NORTHERN BEACHES LOCAL PLANNING PANEL MEETING

WEDNESDAY 18 DECEMBER 2019

3.1	DA2019/0748 - 19 Bungan Street, Mona Vale - Demolition of all existing structures and the construction of a four storey shop top housing development over basement car parking	5

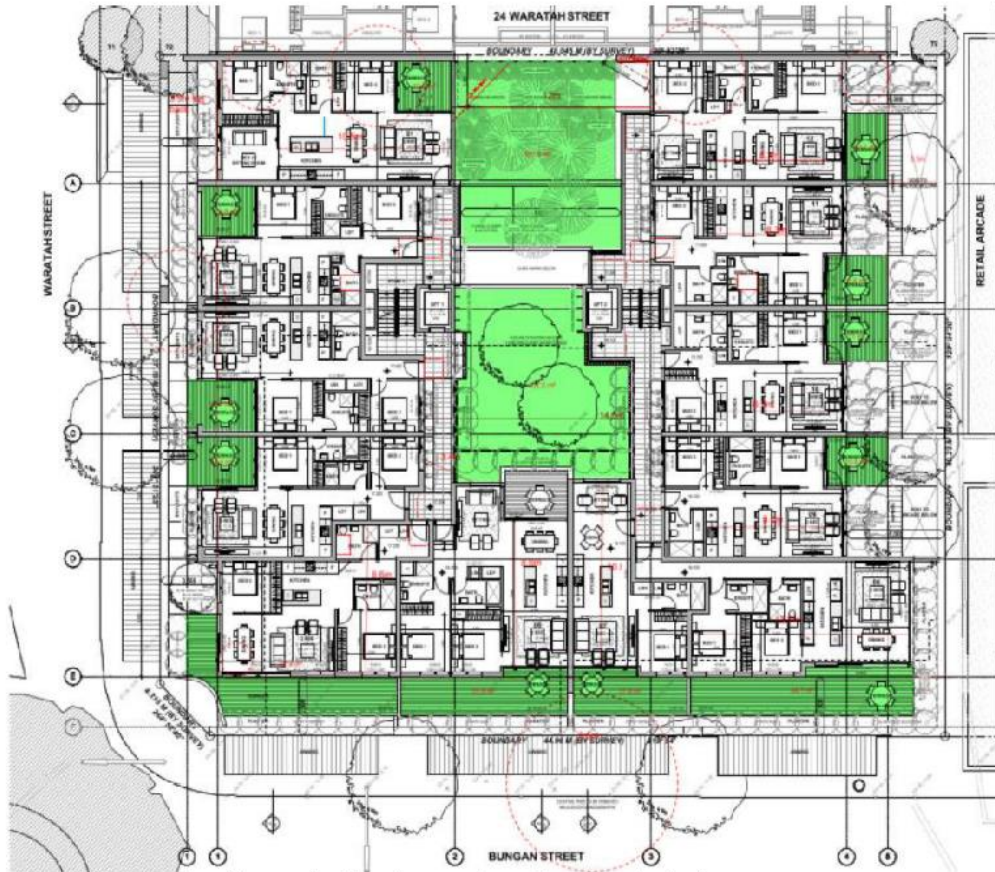
The Clause does not permit an access driveway from allotments adjoining Waratah Street, and Park Street in the Mona Vale Commercial Precinct onto either Bungan Street or Waratah Street where alternative access to a local road is available or can be made available via a right-of-way or easement.

The site bound by two primary roads, Waratah Street and Bungan Road with existing access via Waratah Street. The proposed access is also via Waratah Street and as there is no alternative access to a local road this arrangement has been assessed as acceptable by Council's Transport Unit.

Level 1 plan showing the central landscaped courtyard and private open space.

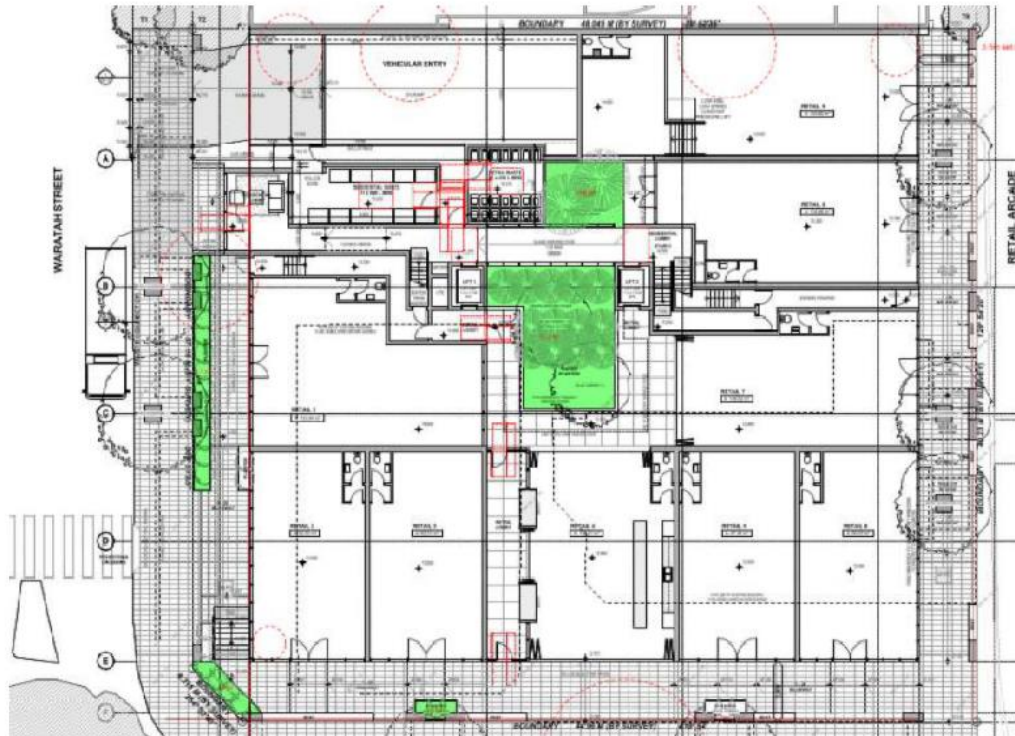
For shop top housing, Clause C1 requires a minimum landscaped area of 20% of the site area, or 35m² per dwelling, whichever is the greater. The proposal provides a 209sqm landscaped central courtyard, an additional 69sqm of landscaping is proposed within the centre of the retail arcade and 22.4sqm is provided at ground level in the form of planter beds. The total amount of landscaping (300sqm) equates to 15% of the site area (refer to ground and level 1 plans below which show the proposed landscaped areas). Furthermore, each apartment benefits from having generous private terraces (9.9sqm -34sqm) which exceed the minimum 4sqm requirement. While the amount of landscape area does not meet the 20% minimum landscape area requirement the proposal meets the relevant outcomes of the control, as discussed below:

Northern boundary:

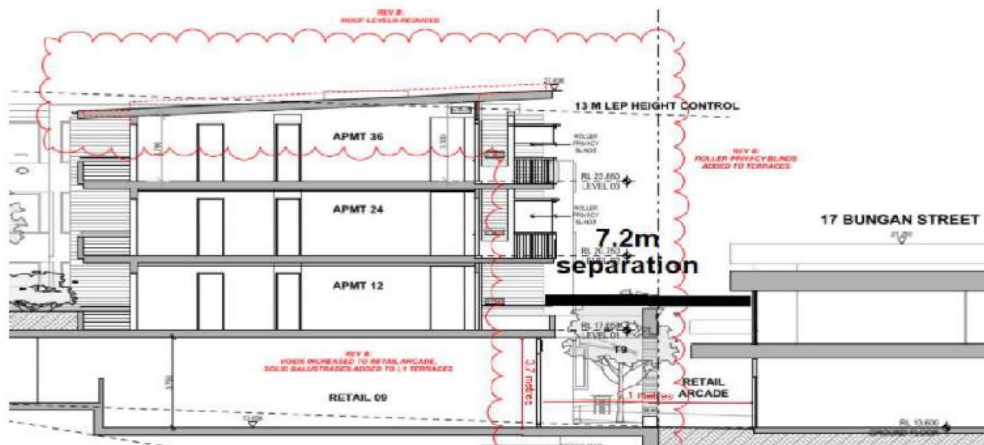
Private terraces to four (4) apartments are located 3.4m from the northern boundary on all three levels (refer to section below). A two storey commercial building is located to the north at No 17 Bungan Street which has first floor windows in the northern elevation, see image below.

In summary, the setback of the terraces and windows to the northern boundary will not result in unreasonable privacy impacts to the commercial development to the north and it is not expected that the development will prejudice the development potential of the neighbouring commercial buildings to the north.

Extract from level 1 plan showing the relationship of proposed windows and terraces to the west (rear) boundary and 24 Waratah Street.

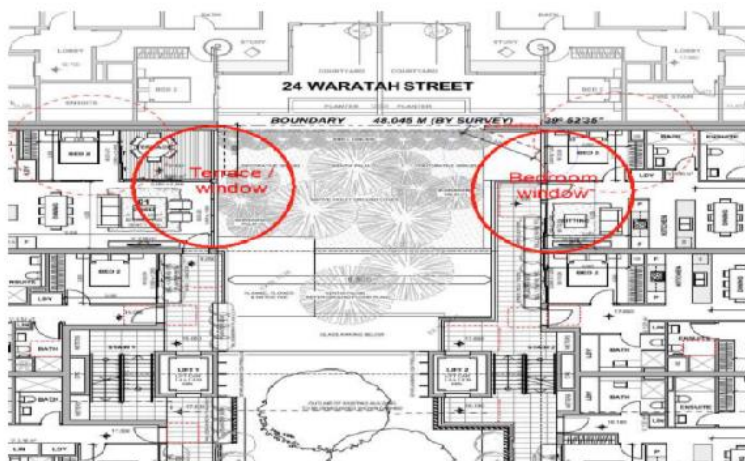
The south facing bedroom windows to unit 12, 24 and 36 are located 3m (measured at an angle of 45 degrees) from the rear boundary to No 24 Waratah Street. A 2m blade wall projects along this boundary which will ensure privacy is protected and the windows are assessed as acceptable. Refer to plan below.

D9.6 Front building line

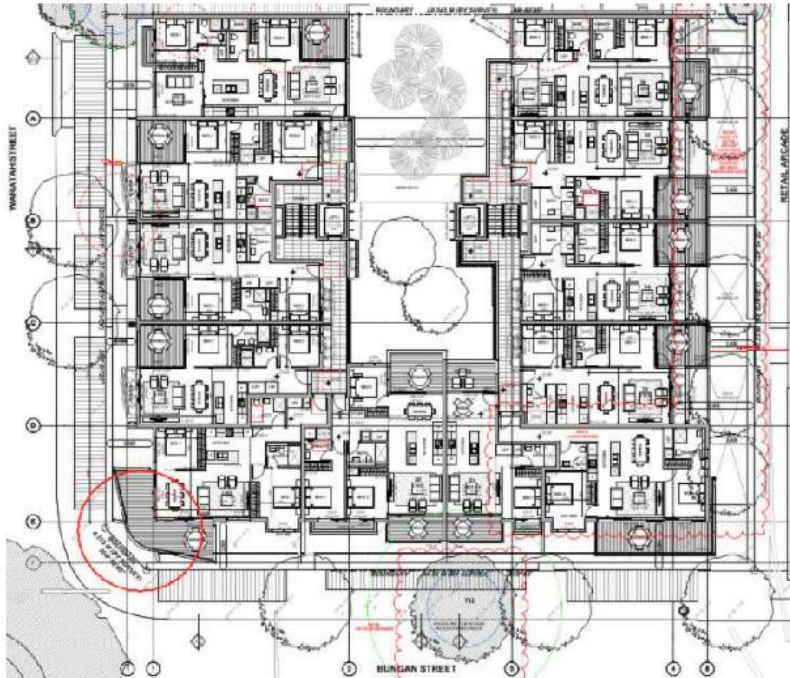
Clause D9.6 requires a 3.5m setback up to a height of 8.49m from the front property boundary, then 6m above a height of 8.5m. The proposed development is inconsistent with the minimum front building line as detailed below.

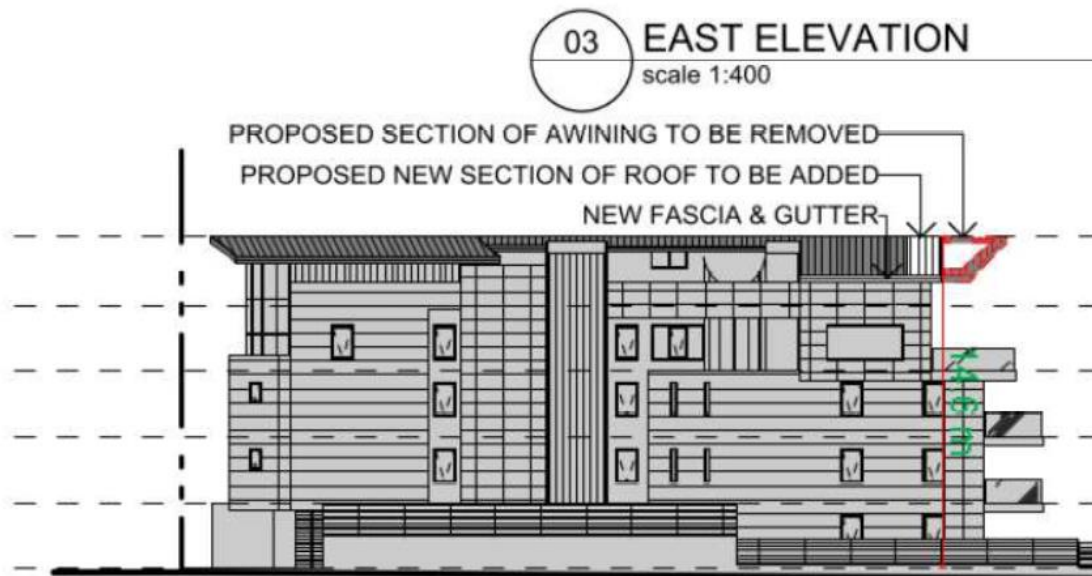
Description of non-compliance:

Development standard:	Height of buildings
Requirement:	13.0m
Proposed:	14.6m
Percentage variation to requirement:	12.3%

The following assessment of the variation to Clause 4.3 Height of Buildings has taken into consideration the recent judgement contained within *Initial Action Pty Ltd v Woollahra Municipal Council* [2018] NSWLEC 118, *Baron Corporation Pty Limited v Council of the City of Sydney* [2019] NSWLEC 61, and *RebelMH Neutral Bay Pty Limited v North Sydney Council* [2019] NSWCA 130.
